Service Manual

CD Stereo System

Model No. **SA-AKX74PH**
SA-AKX74PN
SA-AKX94PH
SA-AKX74PR
SA-AKX94PR

Subject : Updates on Block Diagram, Schematic Diagram, Printed Circuit Board, Exploded View & Parts List.

1/2 2/2 SA-AKX94PH SMPS CIRCUIT

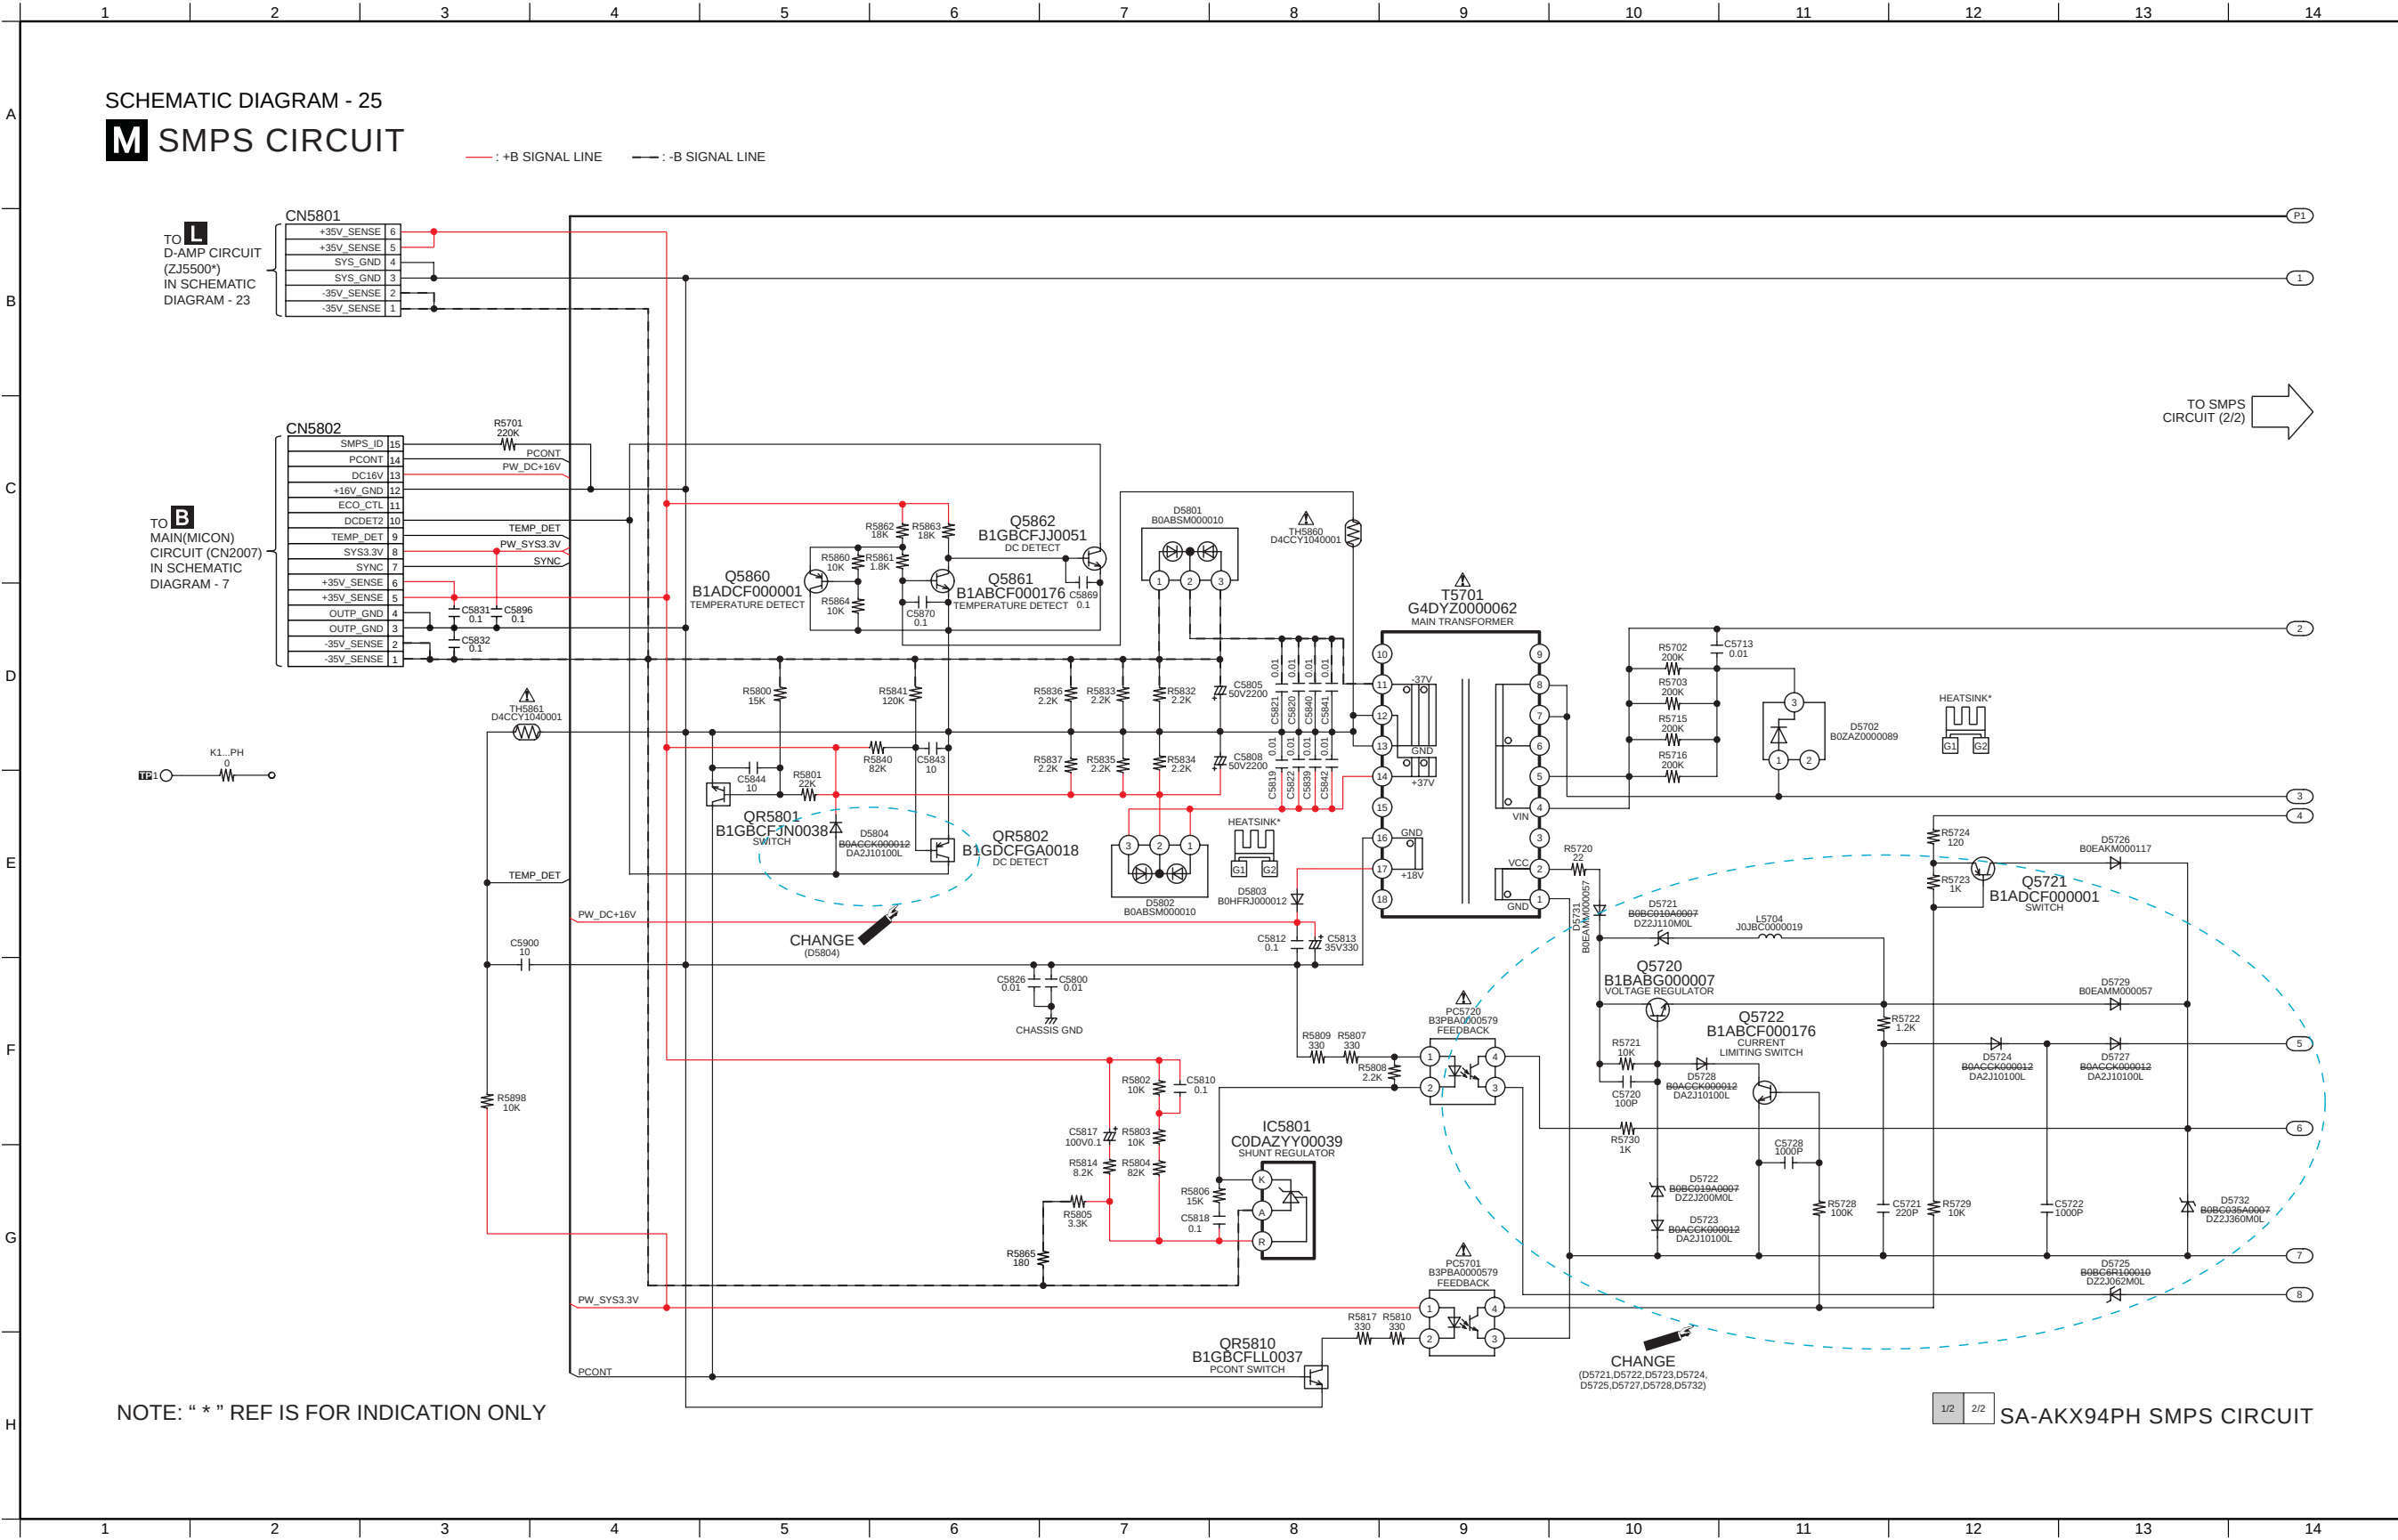
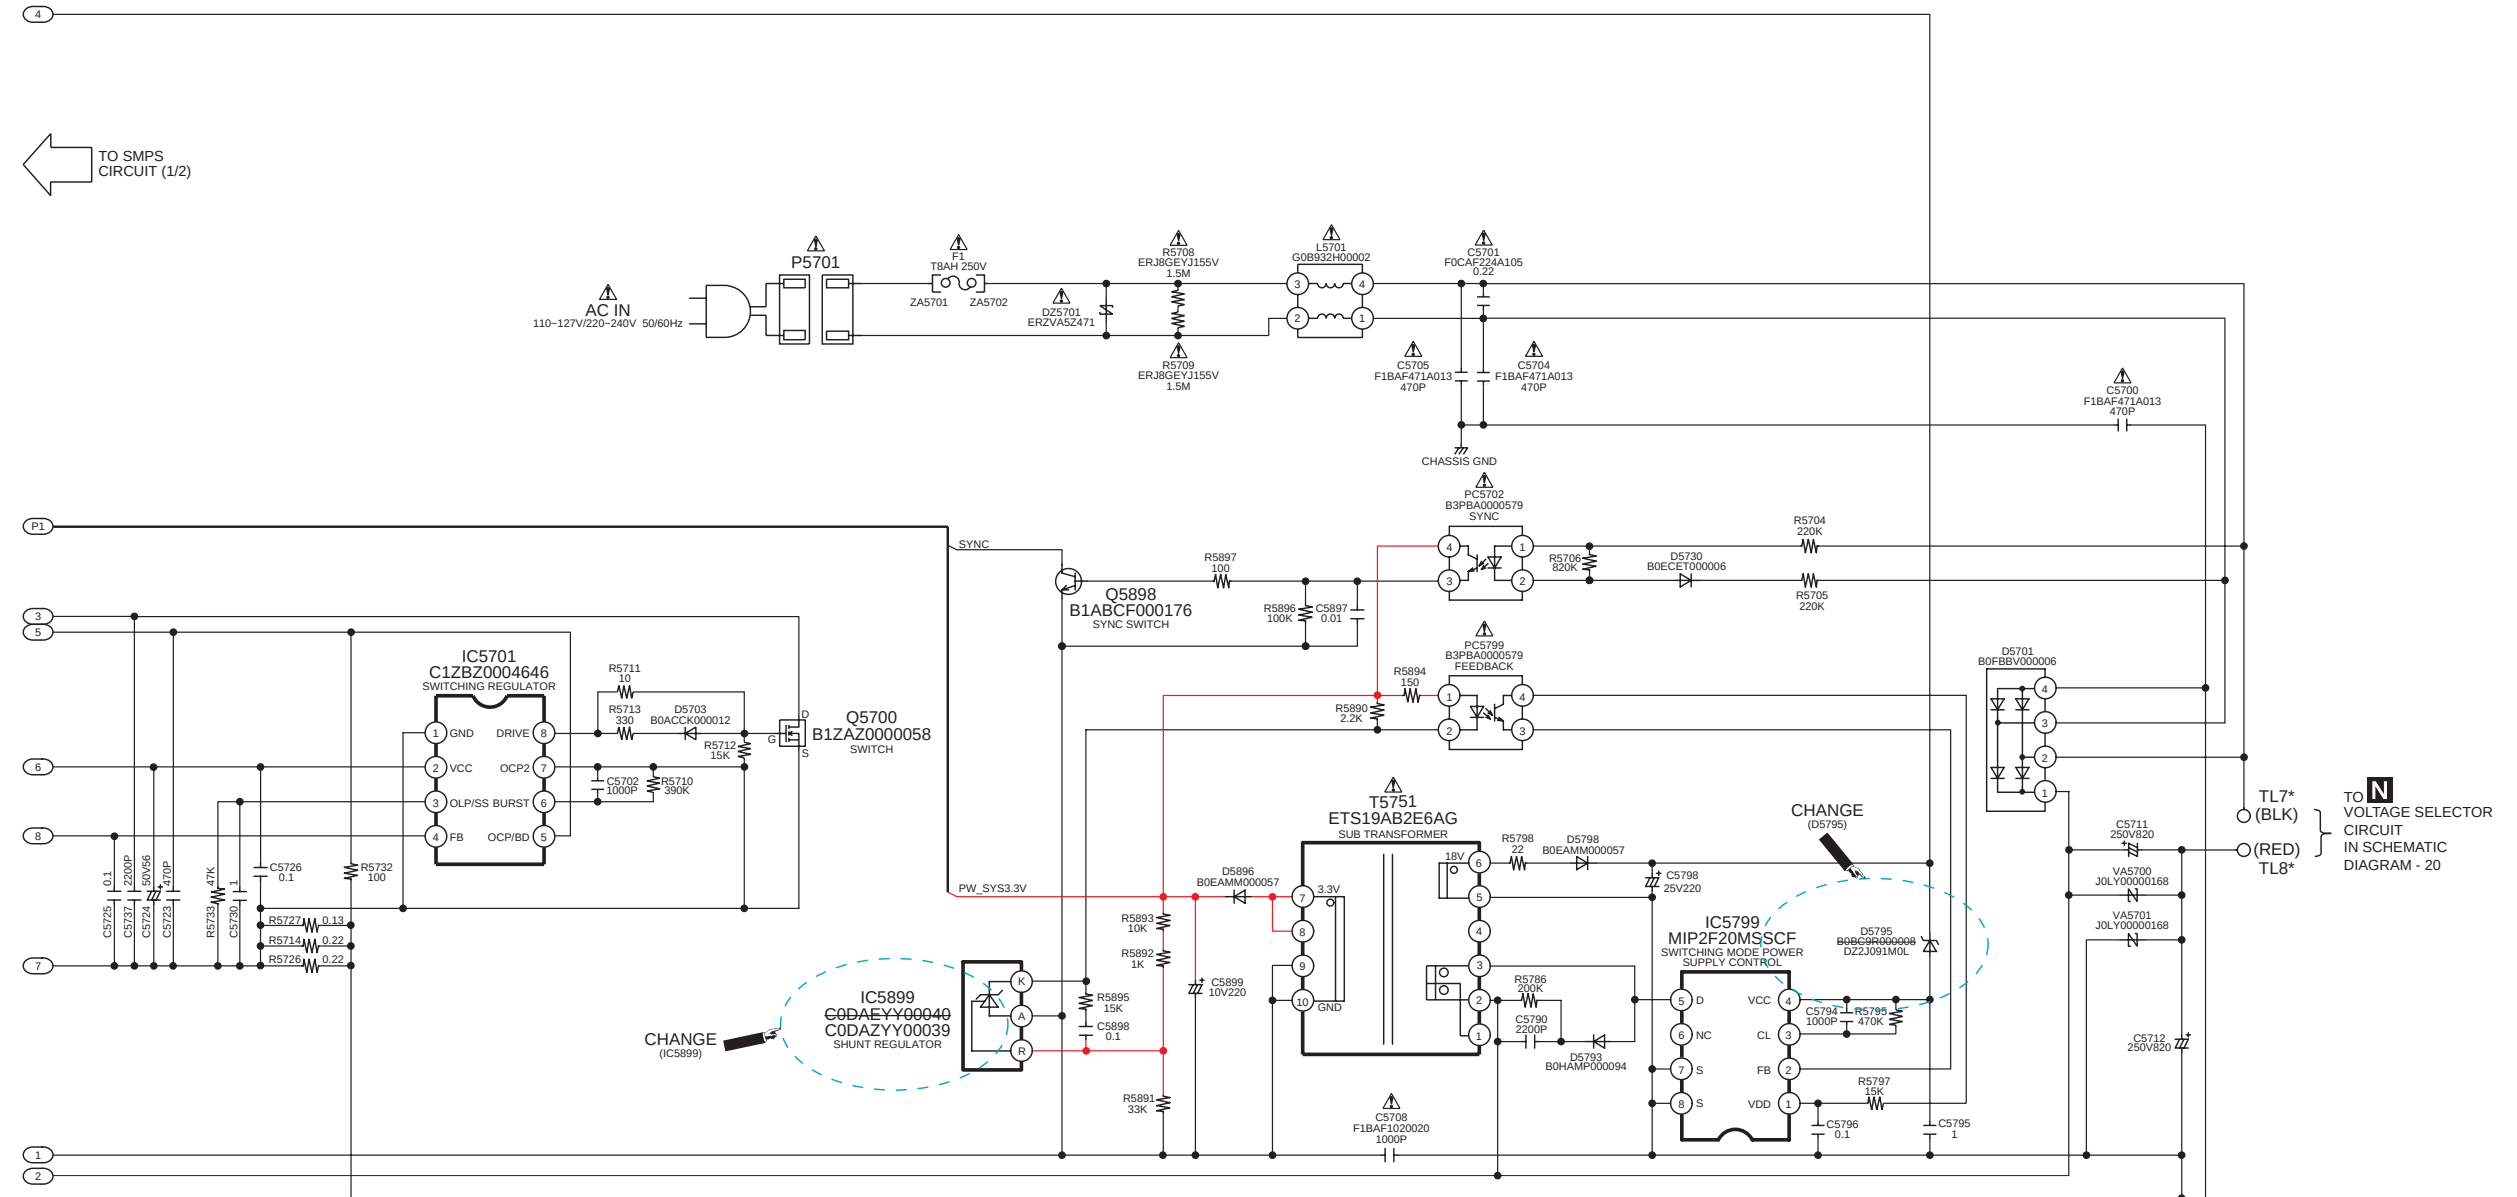
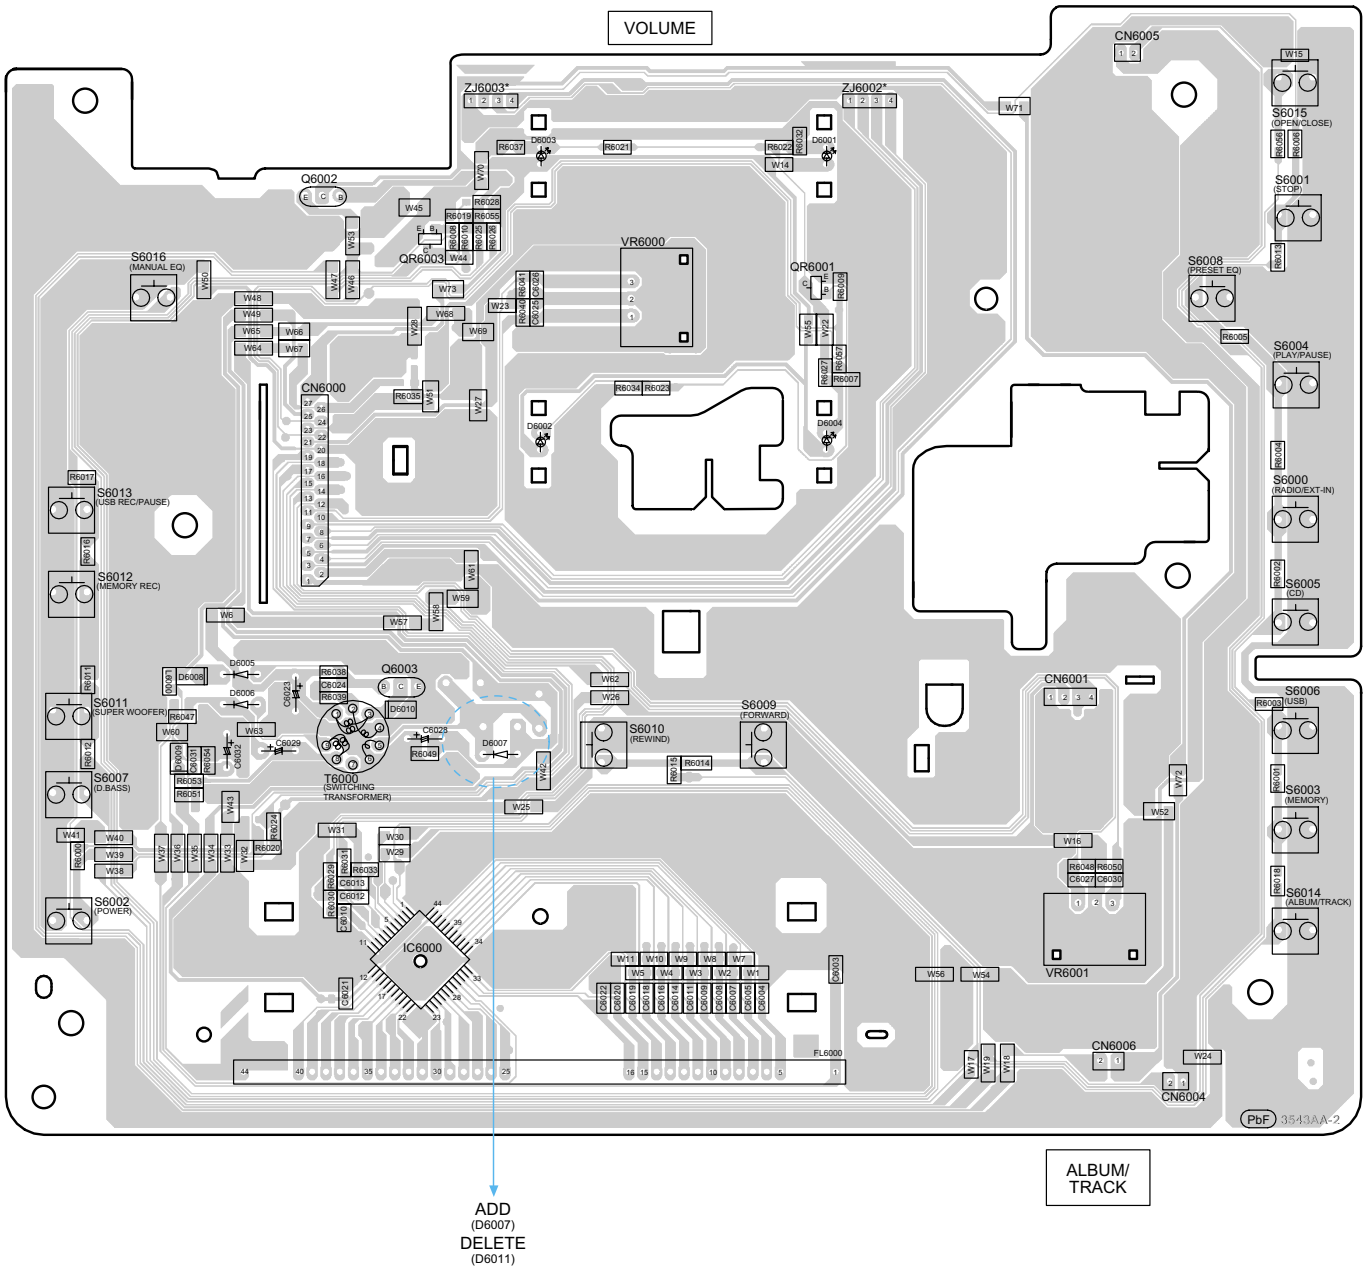
With reference to original service manual (section 16.9) on pages 111 & 112.

SA-AKX74PH/PN
SMPS / D-AMP P.C.B.

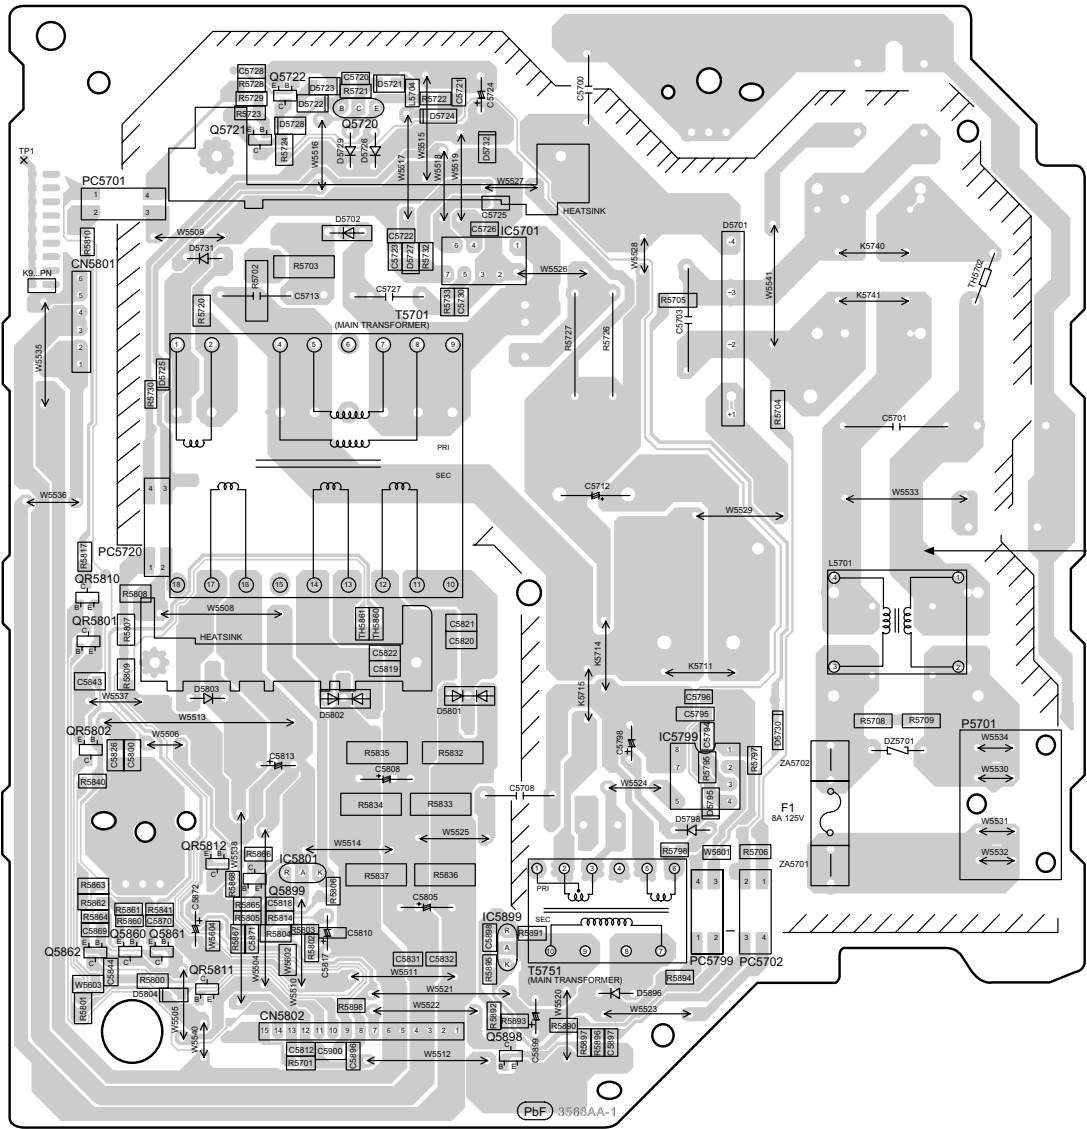
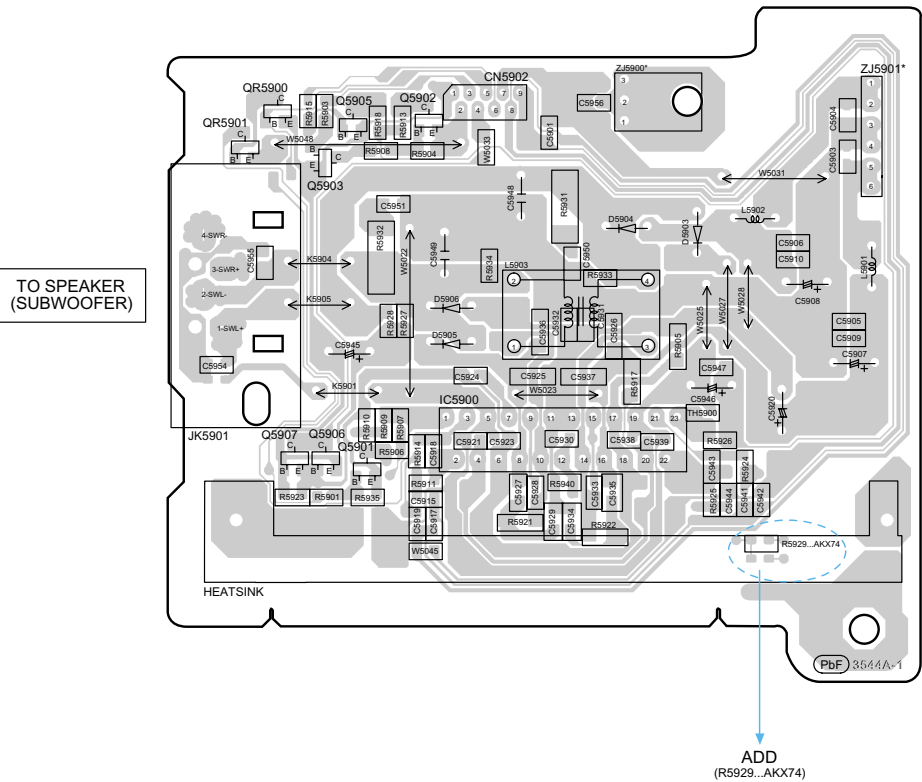
With reference to original service manual (section 17.7) on page 112.
